PERCH POND DAM

NDI ID NO. PA-00135
DER ID NO. 64-23

PHASE I INSPECTION REPORT
NATIONAL DAM INSPECTION PROGRAM

Prepared by
Geo-Technical Services, Inc.
CONSULTING ENGINEERS & GEOLOGISTS

**PERCH POND DAM
GENERAL PLAN - FIELD INSPECTION NOTES**

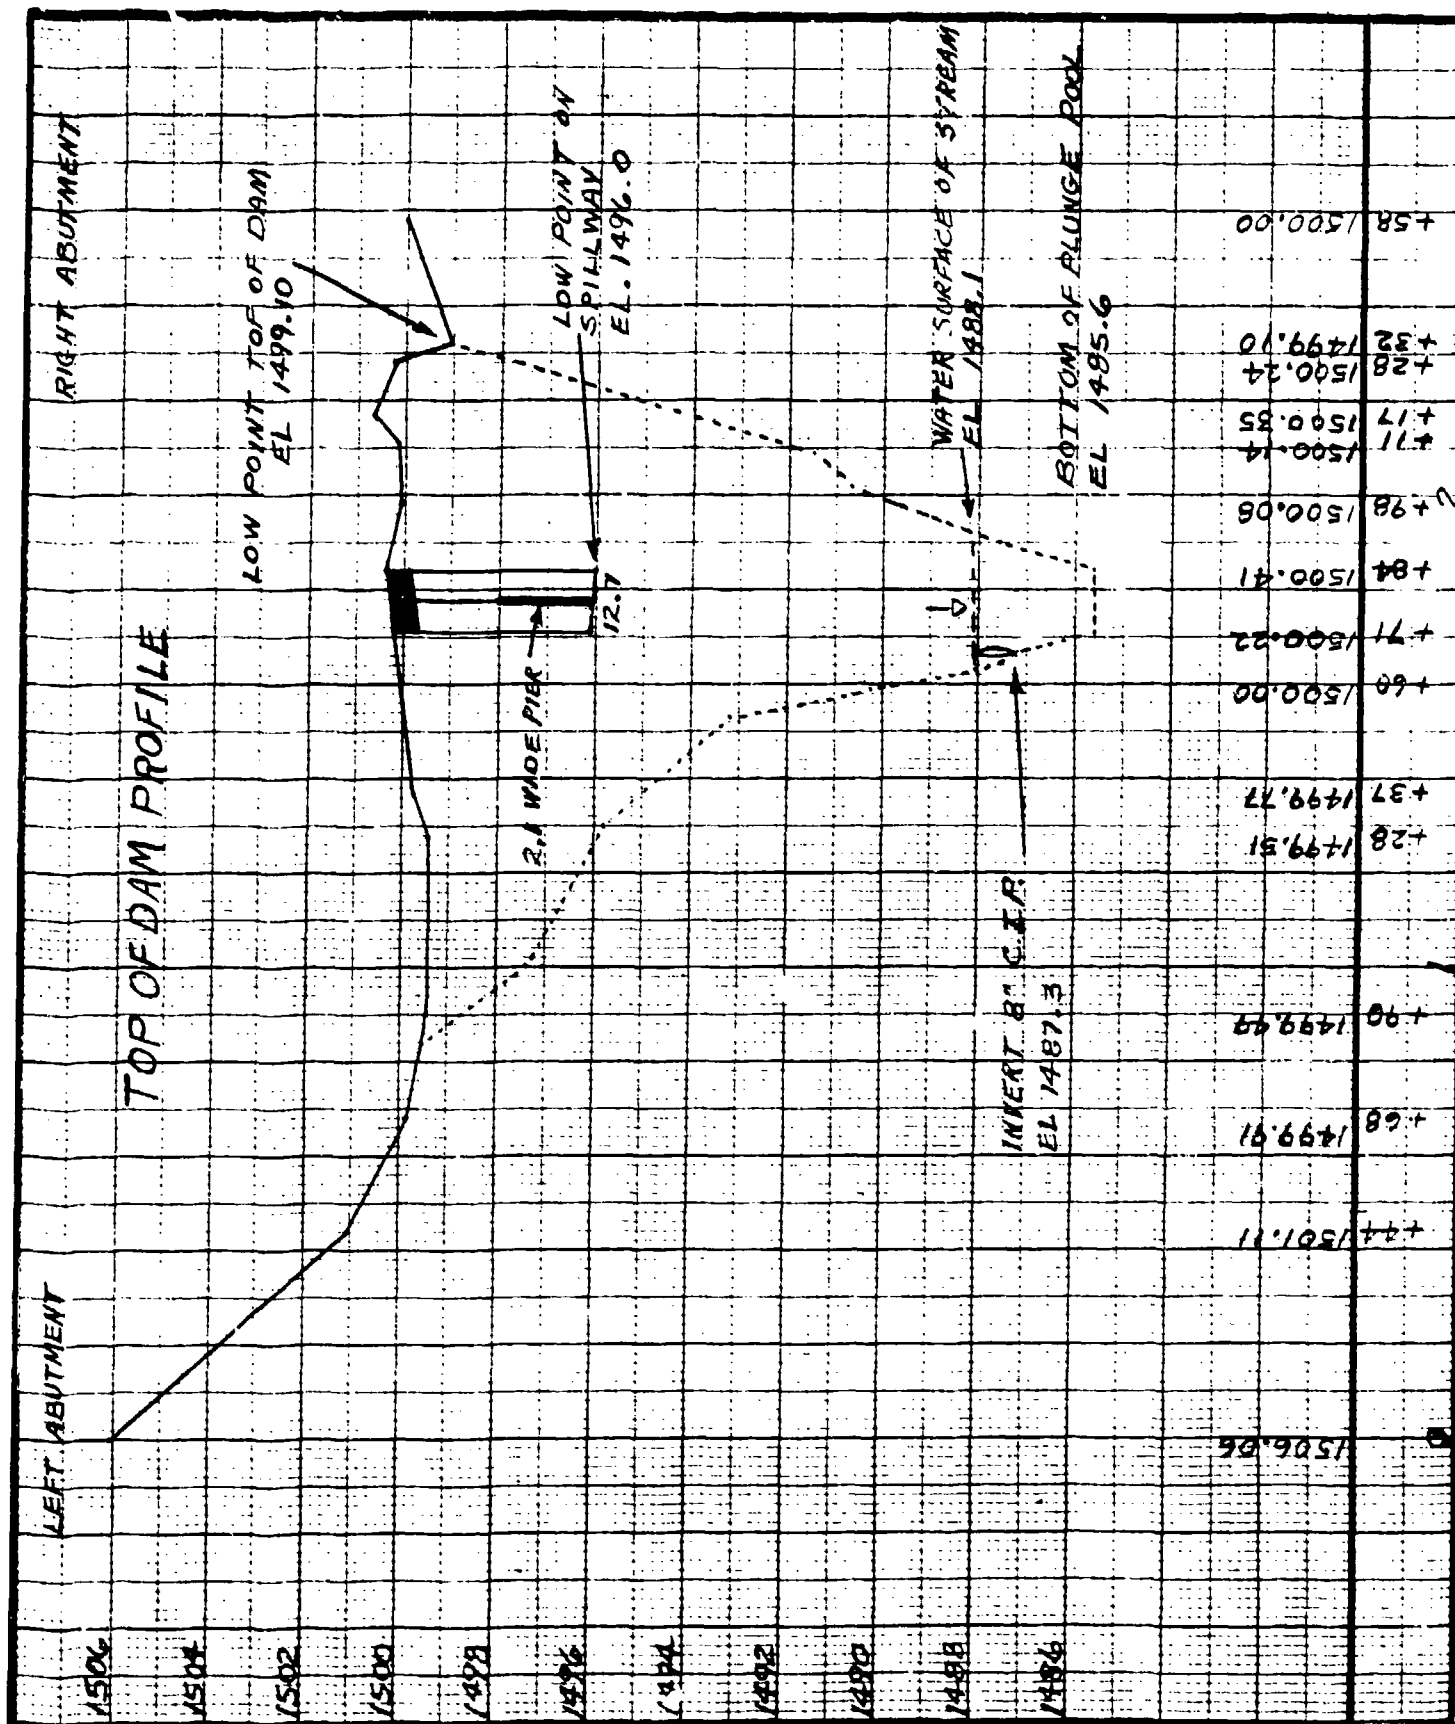
a. General: The overall appearance of the dam and appurtenances is fair. A plan of the dam and annotated field observations are shown on Exhibit A-1, Appendix A. Surveyed profiles and typical sections of the dam are presented in Exhibits A-2 and A-3. The survey datum for this inspection is based on the lake elevation shown on the USGS 7.5 Minute Quadrangle (see Exhibit E-1). Pertinent observed features are indicated on the photographs in Appendix C.

A 30 GPM leak was observed at the bottom of the downstream wall approximately 7 feet left of the spillway. No evidence of internal erosion was noticed (see photograph 19, Appendix C).

(2) Outlet Works: The outlet end of an 8" cast iron pipe is located 3+ feet left of the spillway at the toe of the dam. No inlet structure or gate was observed. The operating condition of the outlet works is unknown.

(4) Remove the trees and brush from the dam crest and the toe of the downstream wall.

(5) Monitor the rate and turbidity of the leakage at the toe of the dam and take appropriate action as required.
